ADDENDUM NO: 01

PROJECT: New Palestine Community Schools Building Demolition Package

PROJECT NO: 2026079

DATE: August 20, 2026

1
C100

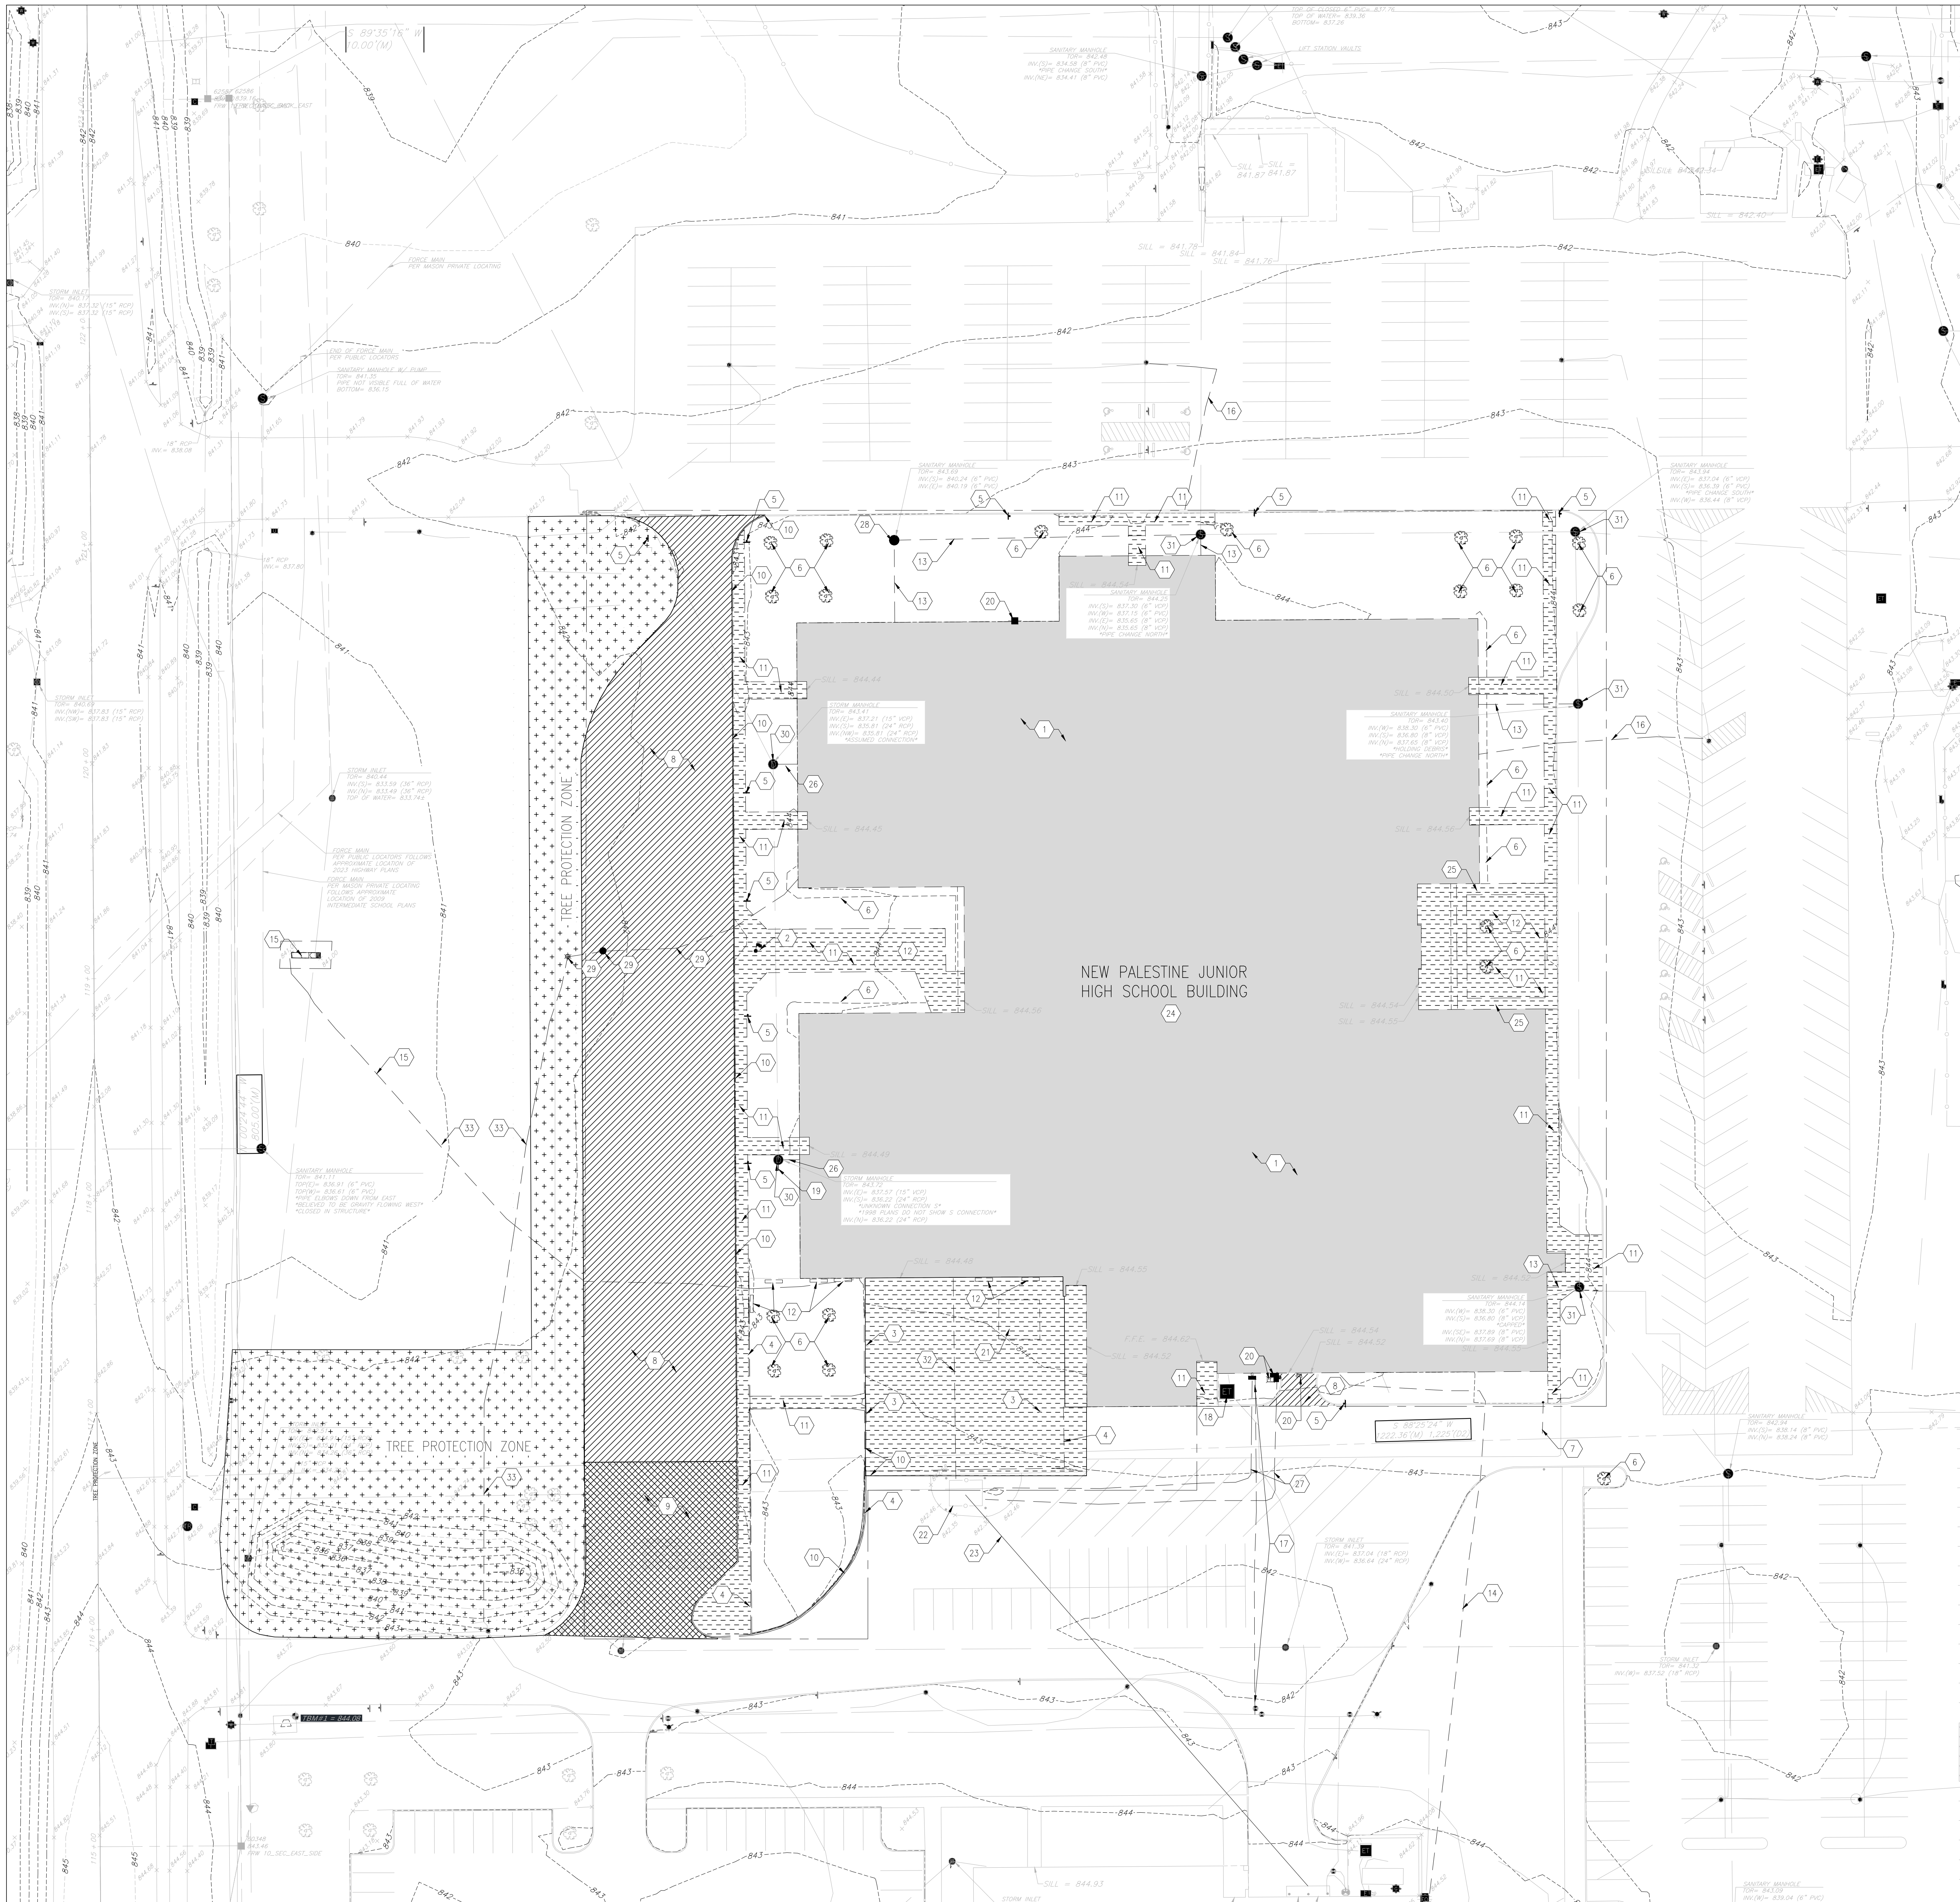
3.4 C100 – EXISTING CONDITIONS & DEMOLITION PLAN

A. Reissue sheet for added clarity.

3.5 C900 – EROSION CONTROL AND SITE GRADING PLAN

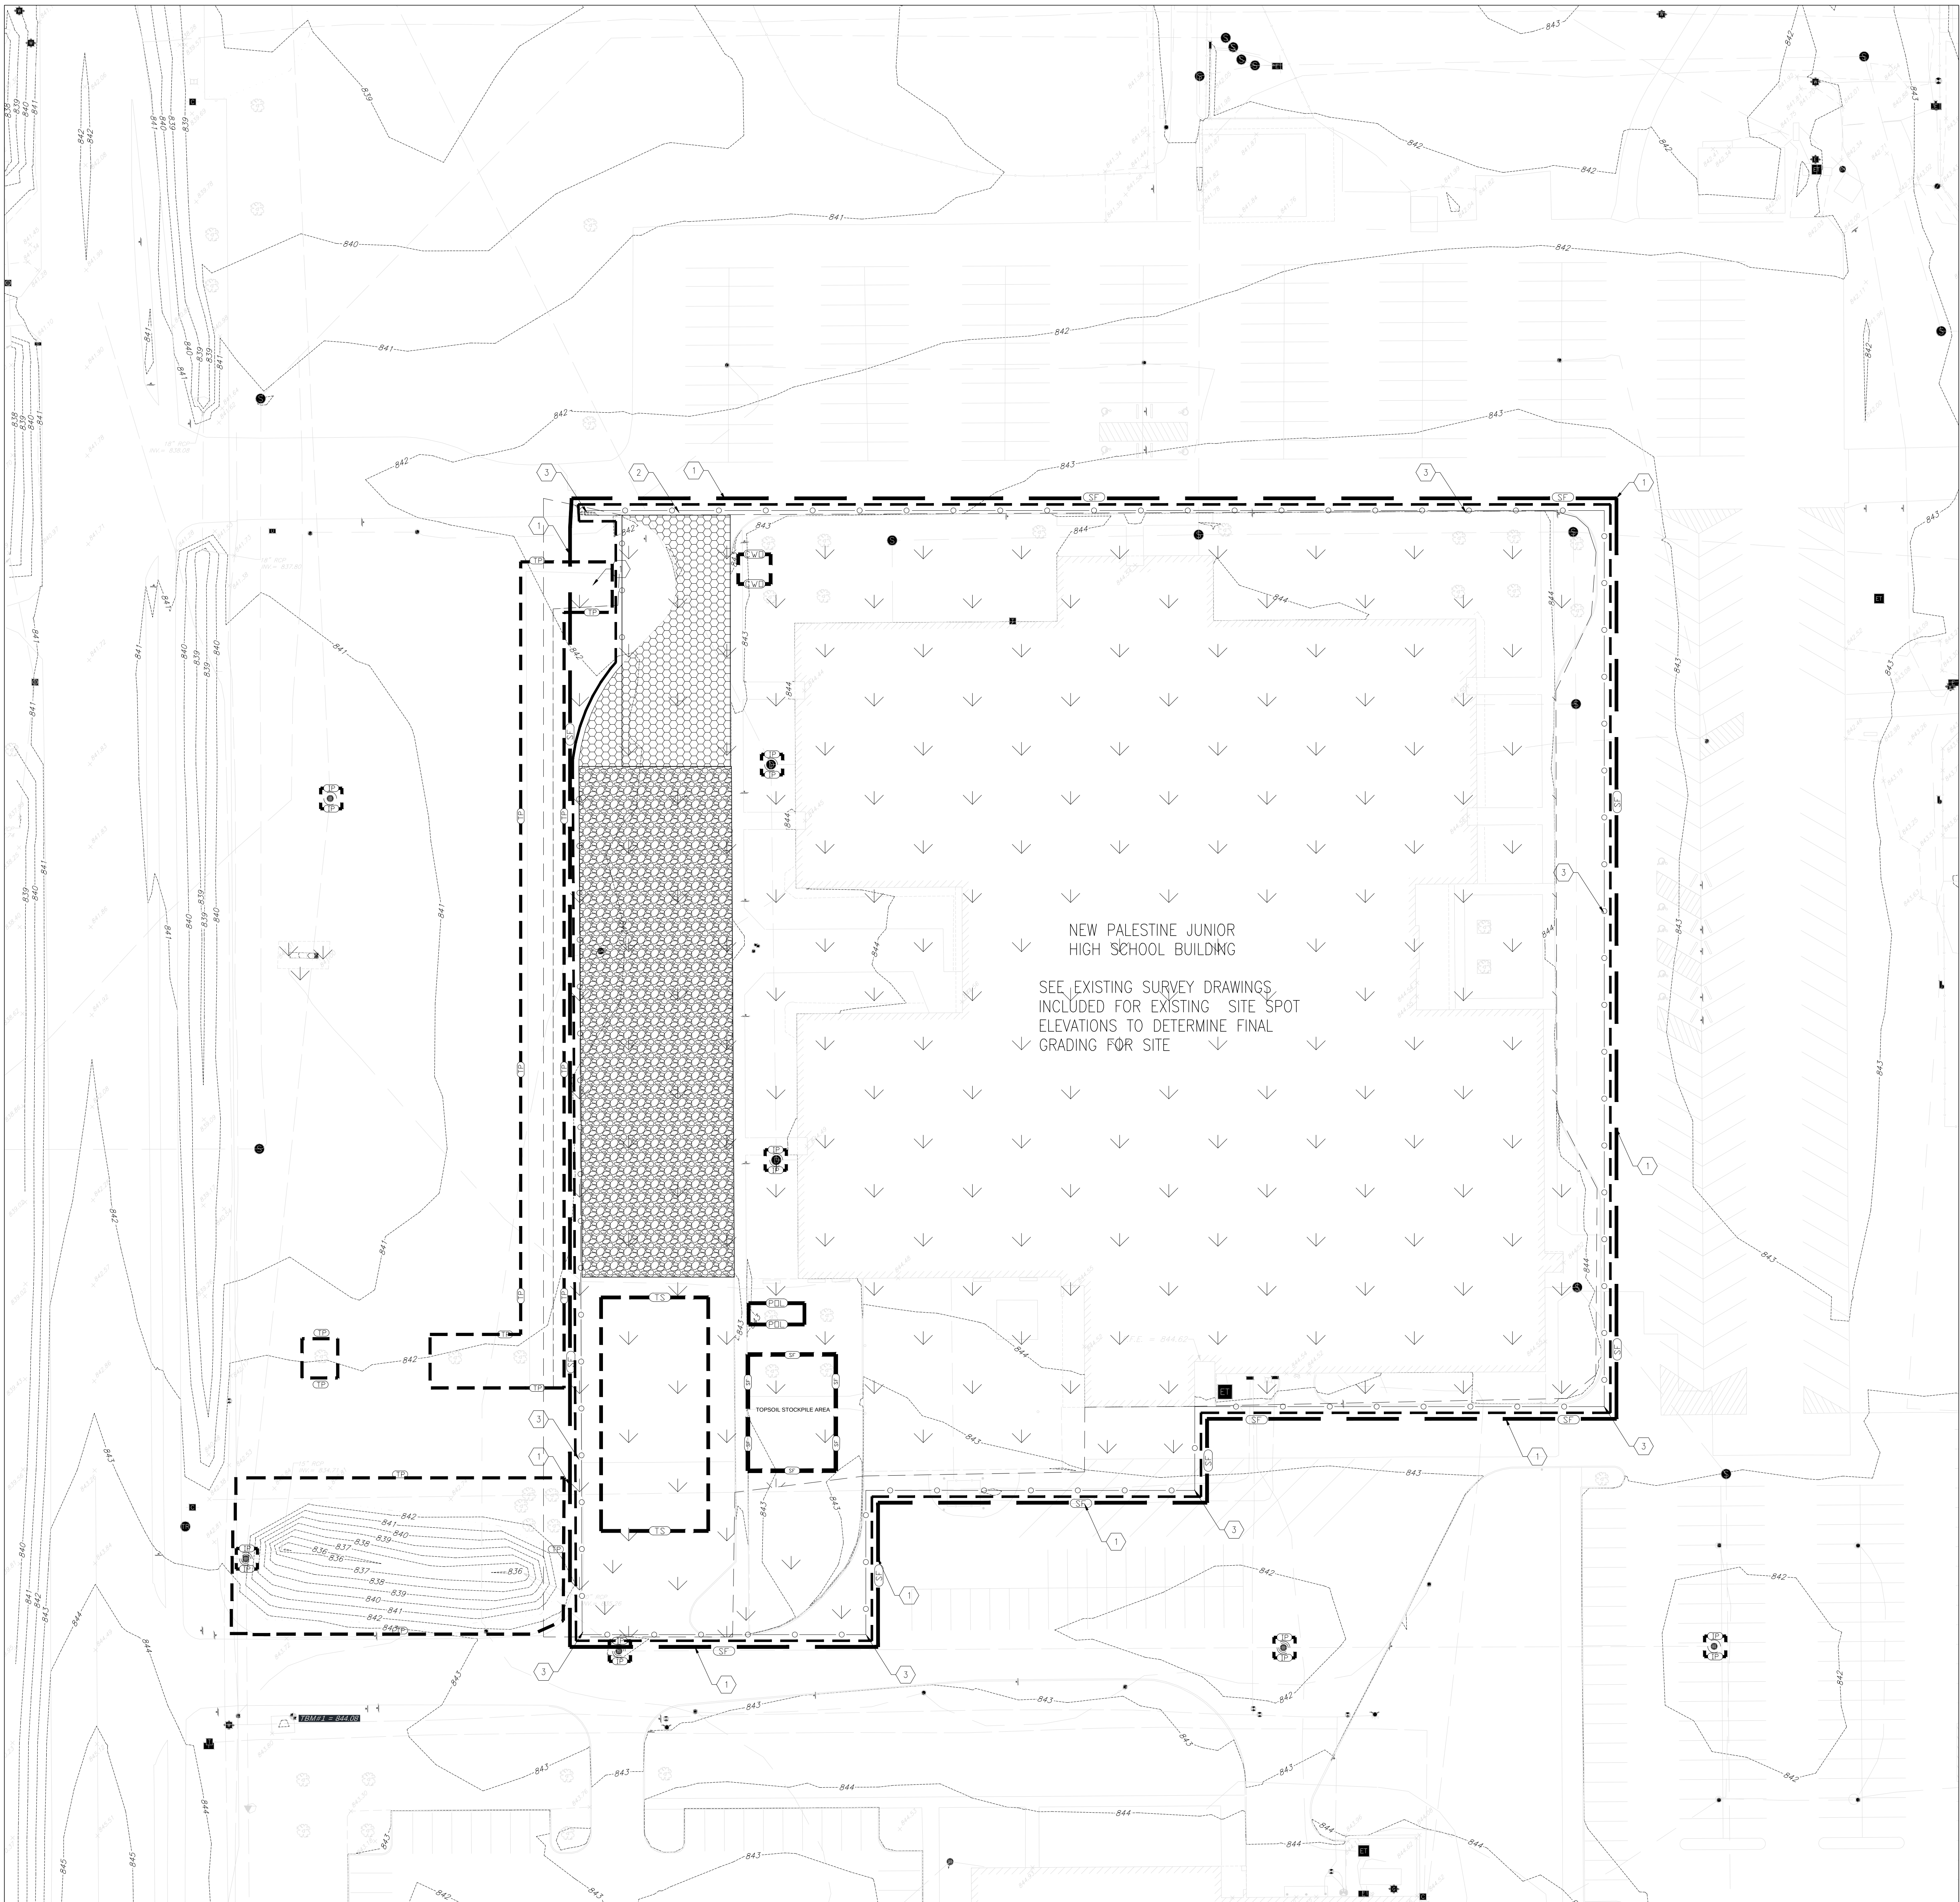
A. Reissue sheet for added clarity.

B. Update sheet name to: **EROSION CONTROL AND SITE GRADING PLAN.**
